FLORIDA POWER AND LIGHT COMPANY
DOCKET NO. 50-250
TURKEY POINT NUCLEAR GENERATING UNIT NO. 3
AMENDMENT TO FACILITY OPERATING LICENSE

Amendment No. 47
License No. DPR-31

ATTACHMENT TO LICENSE AMENDMENT NO. 47

SAFETY EVALUATION BY THE OFFICE OF NUCLEAR REACTOR REGULATION
RELATED TO AMENDMENT NOS. 47 AND 39 TO FACILITY OPERATING
LICENSE NOS. DPR-31 AND DPR-41
FLORIDA POWER AND LIGHT COMPANY
TURKEY POINT NUCLEAR GENERATING UNIT NOS. 3 AND 4
DOCKET NOS. 50-250 AND 50-251

FIGURE 3.2-1

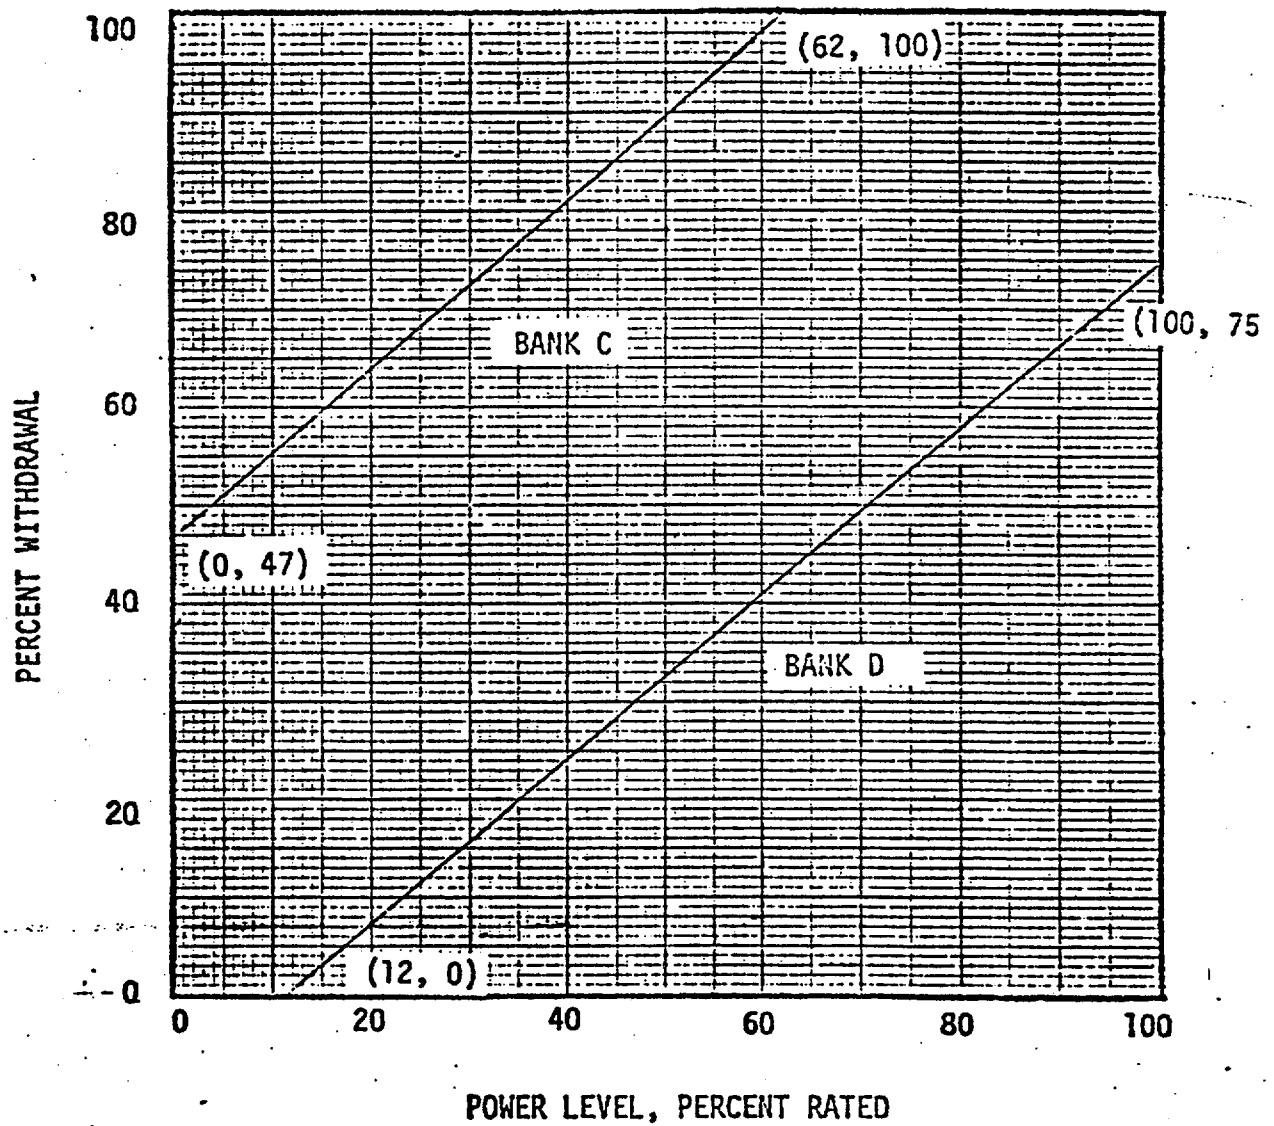
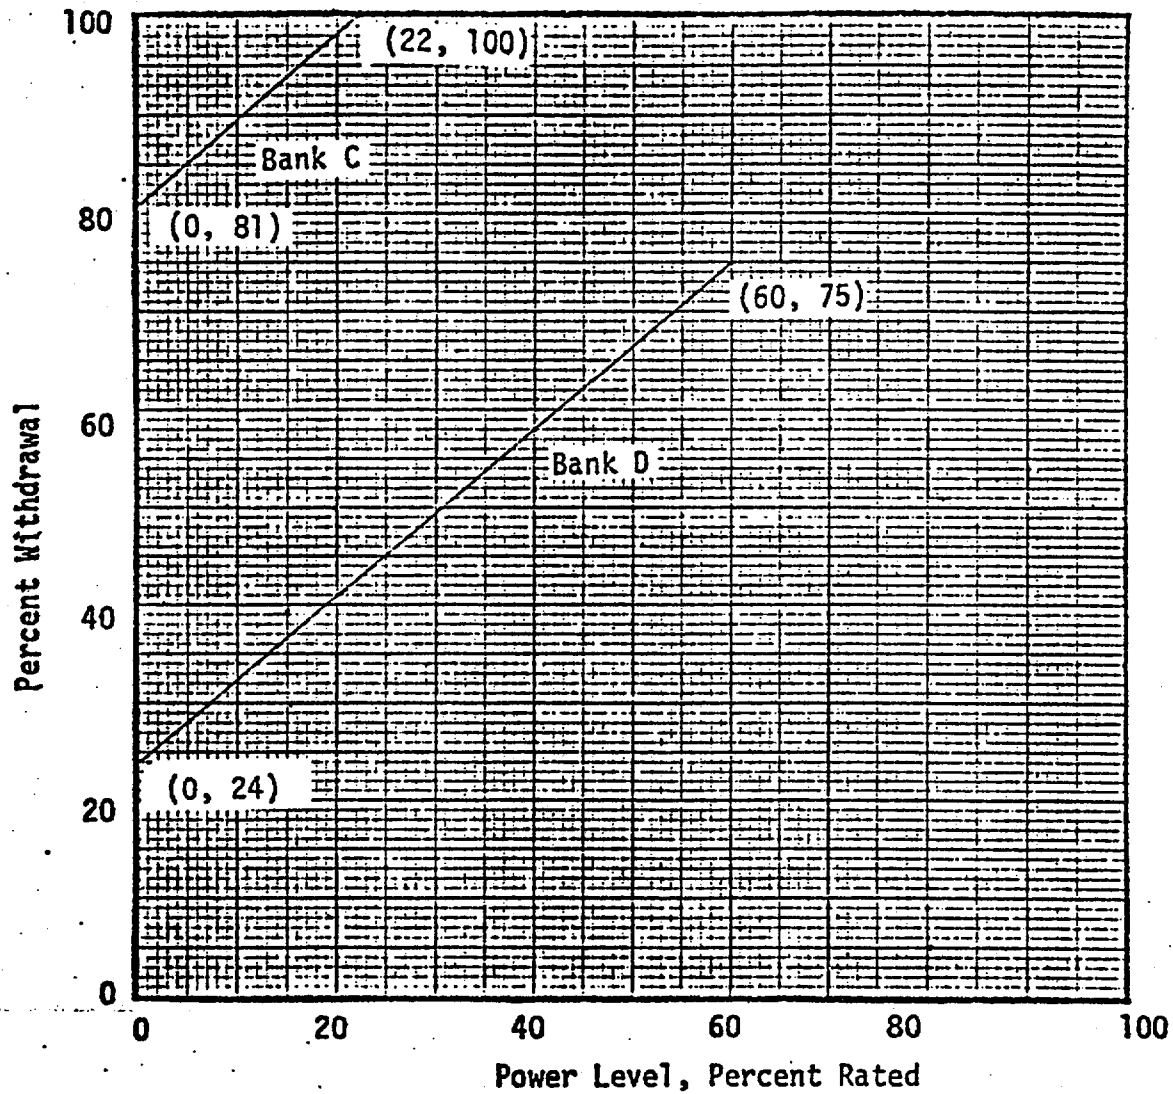
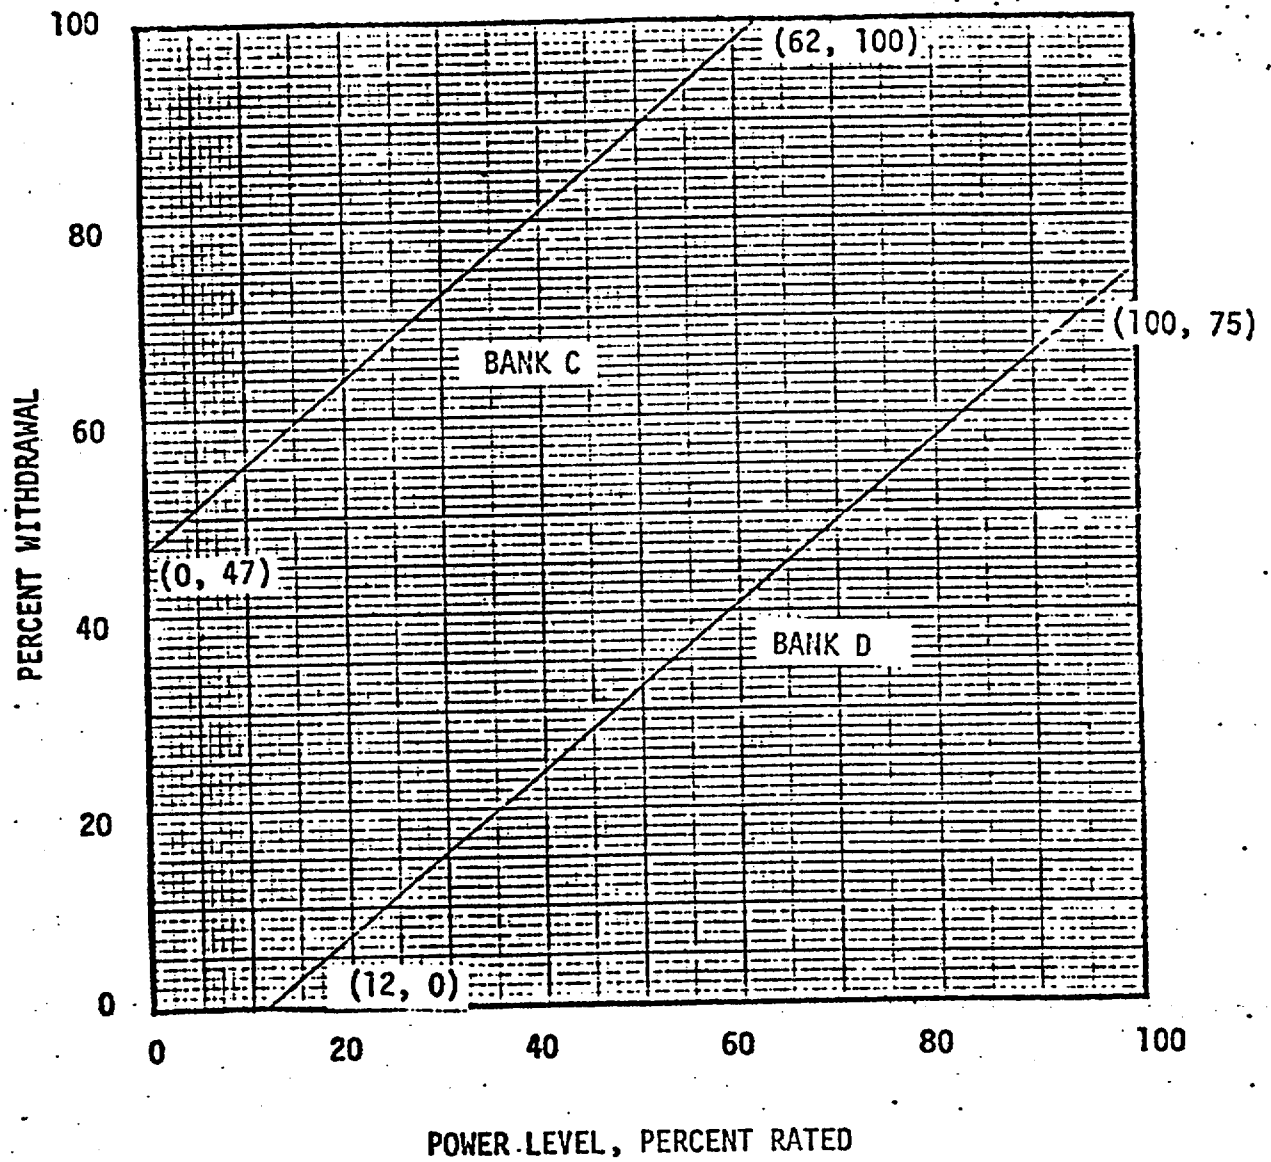
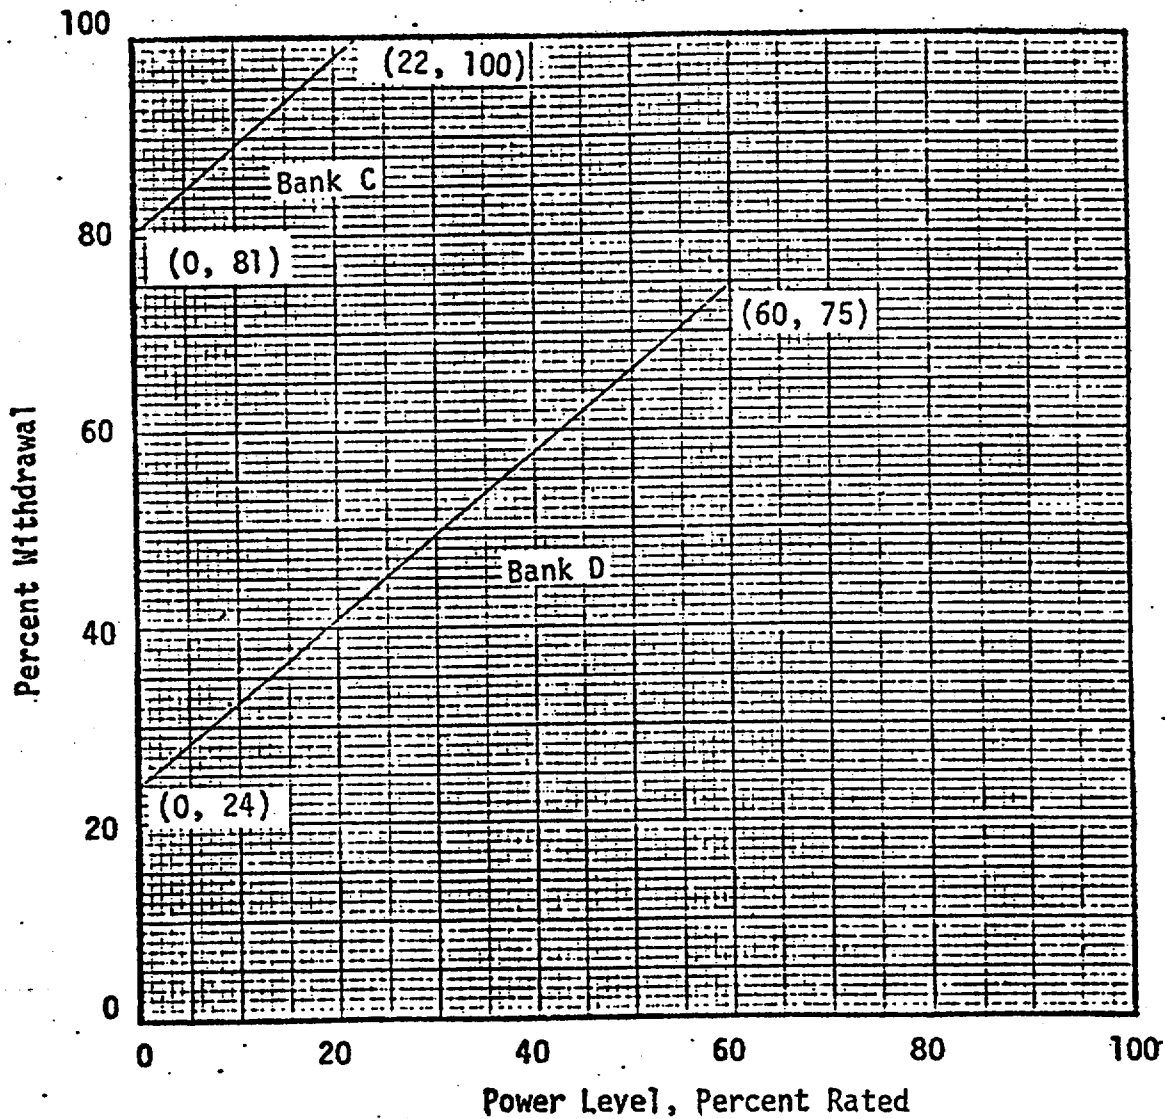
These amendments change the control rod group insertion limits. Paragraphs 6.2.2.f and 6.4.2 were unintentionally left off page 6-5 when that page was revised on February 15, 1979 (Amendment 43 for Unit 3 and Amendment 35 for Unit 4). These amendments correct that administrative error.

The control rod insertion limits are established to ensure that (1) adequate shutdown margin exists, (2) hot channel factors are maintained below design limits and (3) the consequences of a rod ejection accident are acceptable. Insertion limits are determined to give the lowest rod positions which meet these criteria. The Technical Specifications state that the control group rods shall be no further inserted than the limits shown on Figures 3.2-1 and Figures 3.2-1 (a), (b) and (c).

The proposed control rod insertion limits would allow the control group rods to be inserted into the reactor core a lesser amount than do the existing Technical Specification limits. A decrease in the amount of allowed insertion is conservative. It would increase the minimum available shutdown margin, maintain an acceptable core power distribution and decrease the consequences of a control rod ejection accident.

Based on the considerations above, we find that the proposed rod insertion limits are acceptable since they do not involve a significant increase in the probability or consequences of accidents previously considered or a significant decrease in a safety margin. There is reasonable assurance that the health and safety of the public will not be endangered by operation in the proposed manner.
